Project/File: 160402067

**Reference: 930 & 1010 Somerset Street West
Urban Design Review Panel Report**

1010 Somerset Street West | Informal Review | Plan of Subdivision and Zoning By-law Amendment | City of Ottawa/ Barry Hobin Architecture

SITE PLAN | Proposed

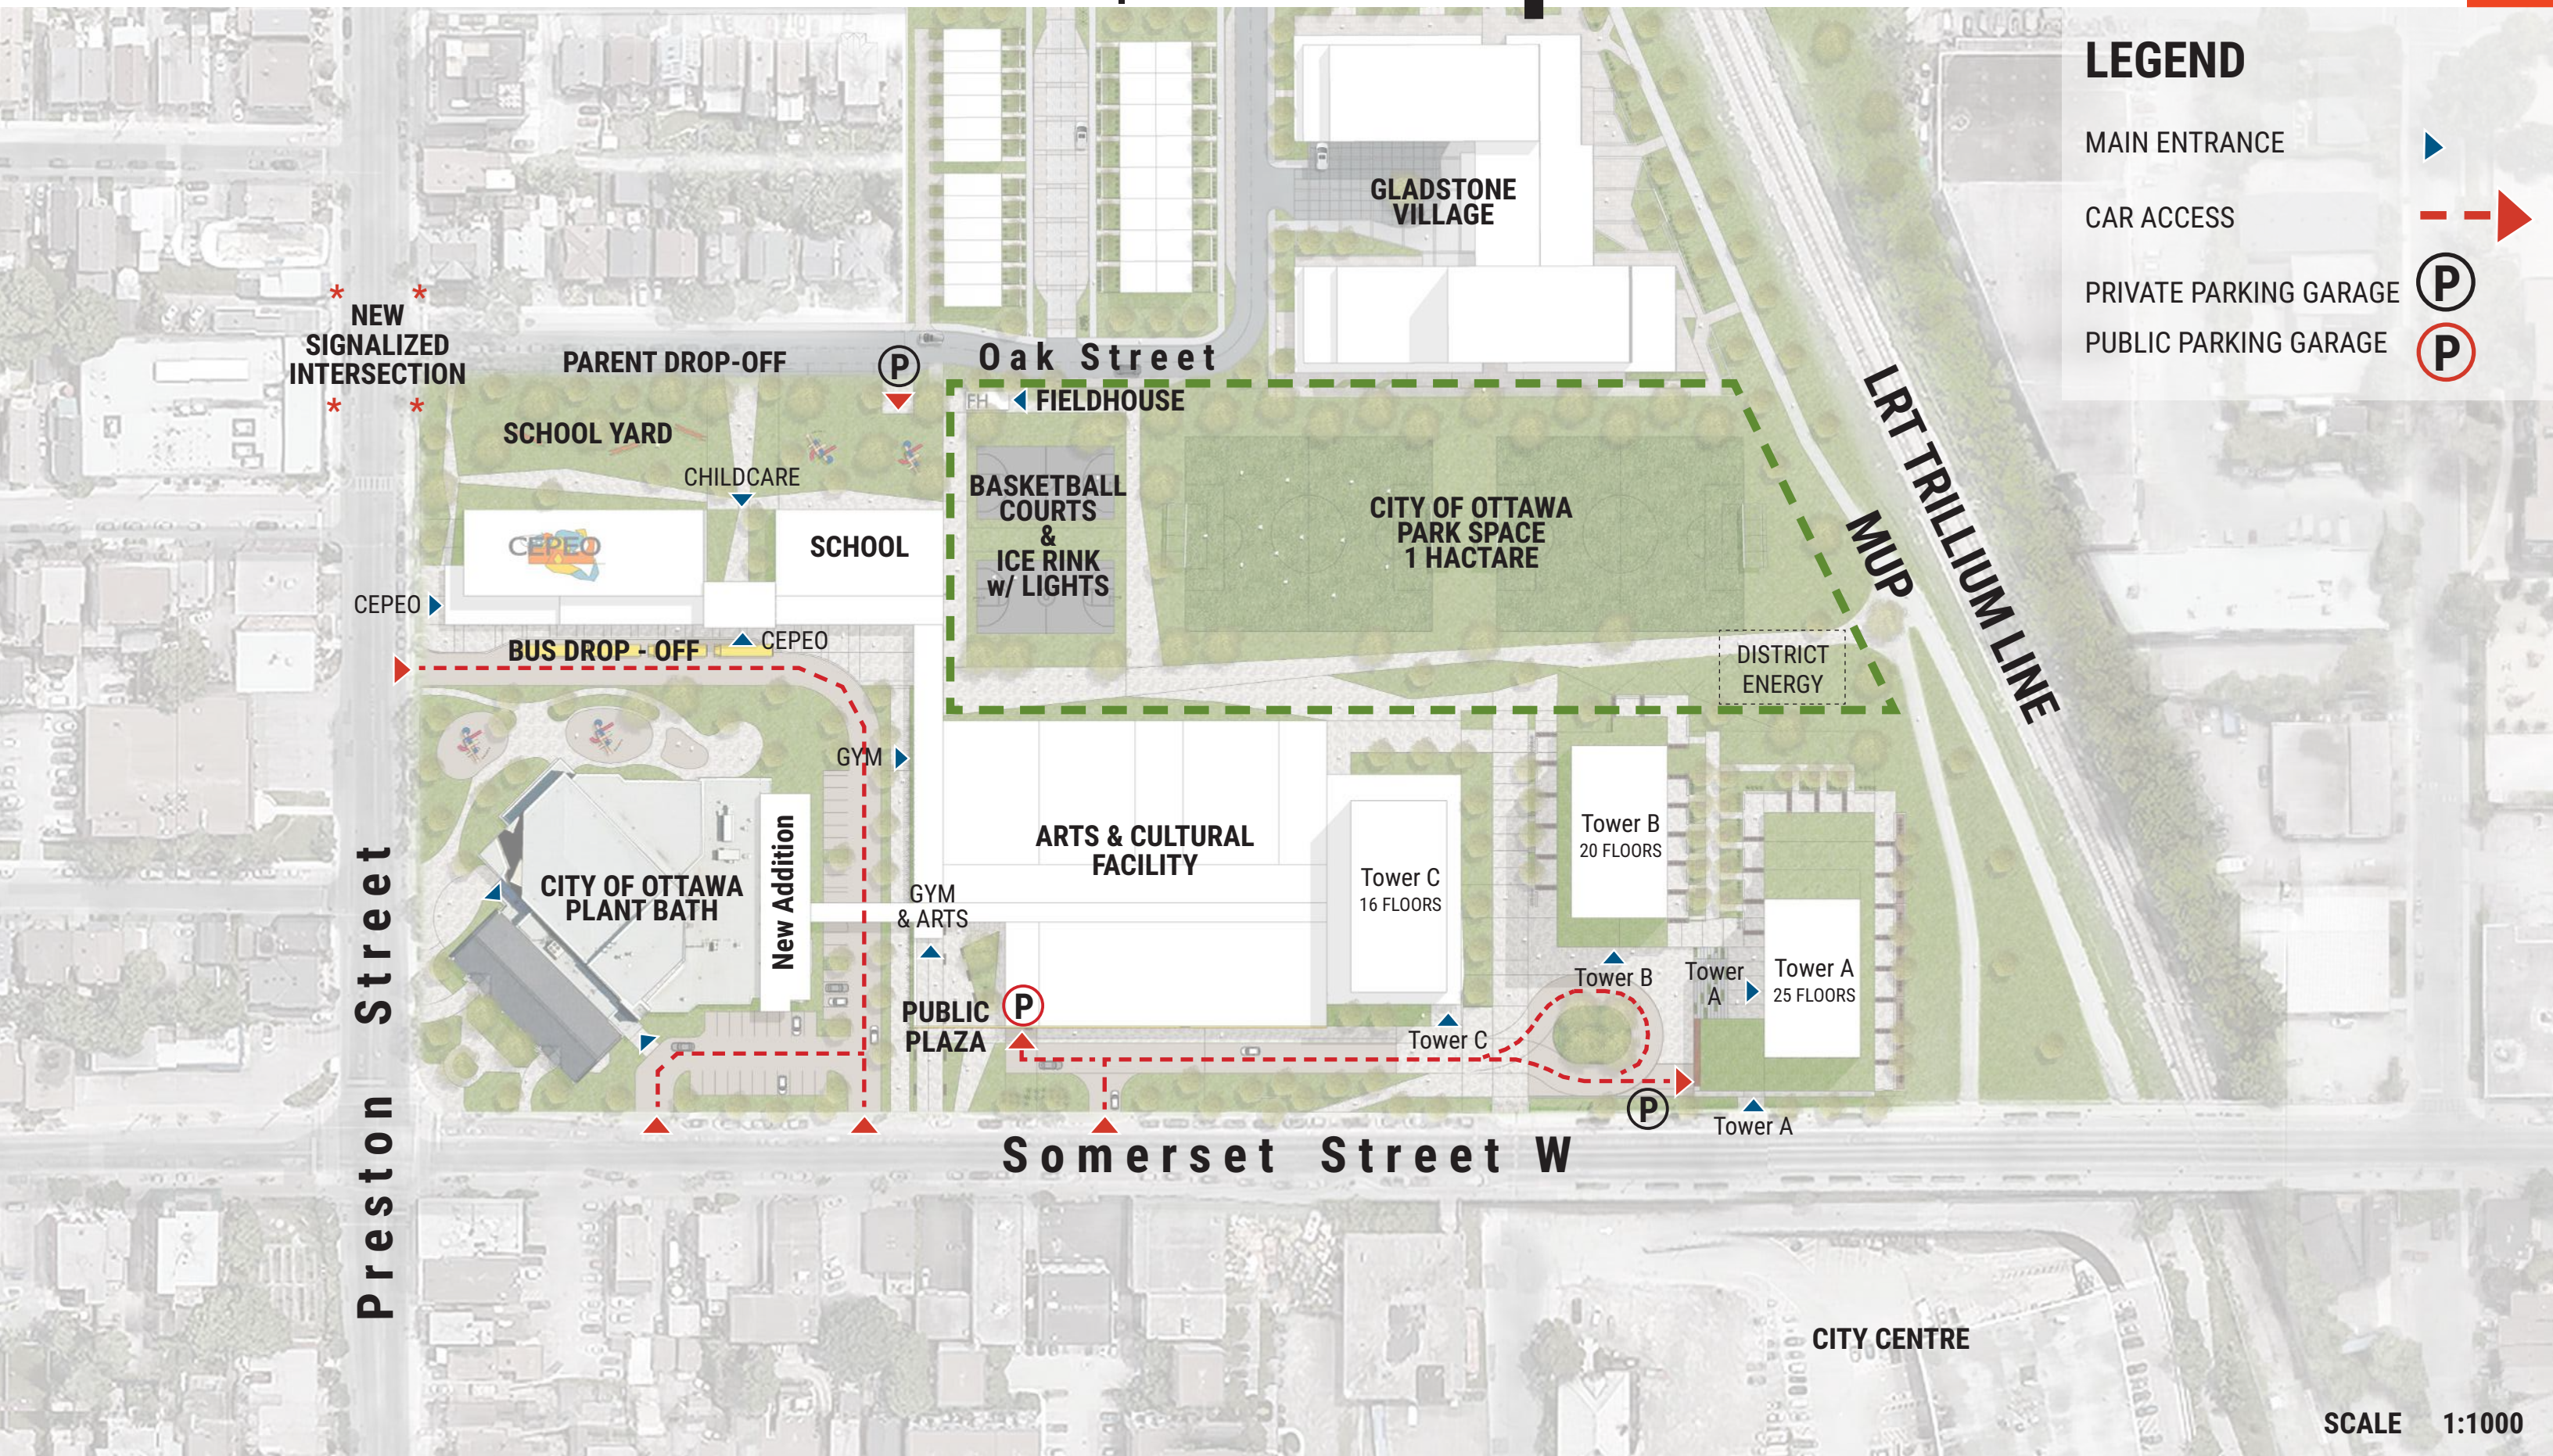
- The current parking garage access location abutting the Plaza is a concern as it requires the long parallel access drive in its current location. and it should be re-located.

- The service lane located parallel to Somerset Street West is a significant concern. Reduction or removal of this element should be explored as it has a direct impact on the abutting public realm relationship and diminishes the importance of this main street frontage.

Placemaking is pivotal to the success of the project. This requires making the Public Plaza the heart of the district. This public space should be animated and tell a story.	Lands identified previously as a public plaza are currently not owned by the City of Ottawa and are occupied by two mixed use buildings. It is our understanding that the City will continue to explore the merits of acquiring these properties. The revised Concept Plan provides multiple opportunities for public gathering spaces.
The current parking garage access location abutting the Plaza is a concern as it requires the long parallel access drive in its current location. and it should be re-located.	The parallel access driveway has been removed and replaced by moving the uses to directly abut the street. Parking access is now located interior to the site.
The service lane located parallel to Somerset Street West is a significant concern. Reduction or removal of this element should be explored as it has a direct impact on the abutting public realm relationship and diminishes the importance of this main street frontage.	The parallel access driveway has been removed and buildings pulled to abut the Somerset Street West frontage.
